SUBJECT: RESPONSE TO NRC INSPECTION REPORT 030-05179/2006-004 AND
NOTICE OF VIOLATION

Subject: "Reply to NOTICE OF VIOLATION" Docket No. 030-05179

MONTANA DEPARTMENT OF TRANSPORTATION NUCLEAR GAUGE STORAGE SITE EVALUATION

8 Troxler Gauges
After Added Shielding
Survey

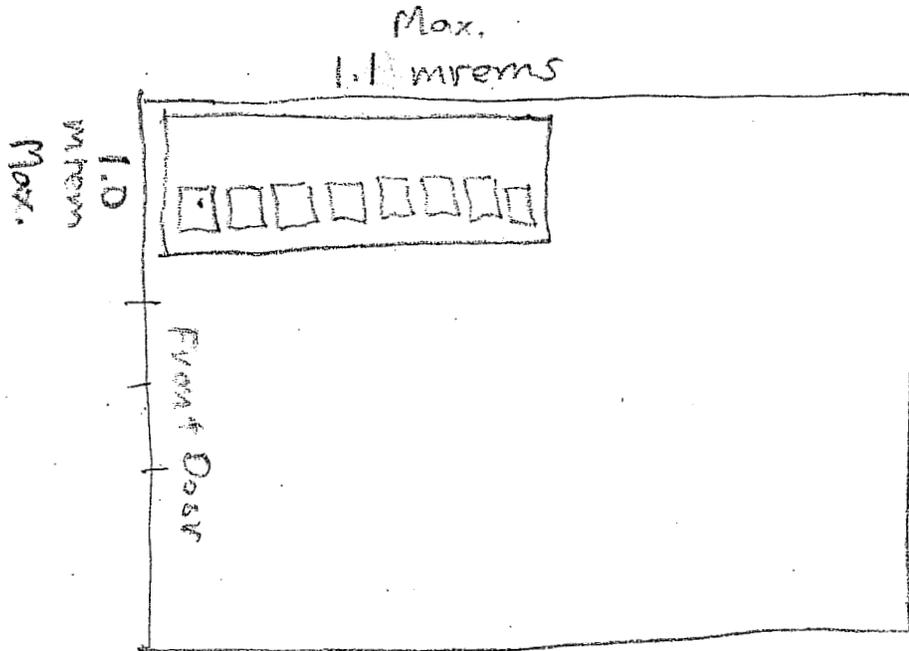
Upgraded wall shielding by filling it with sand.
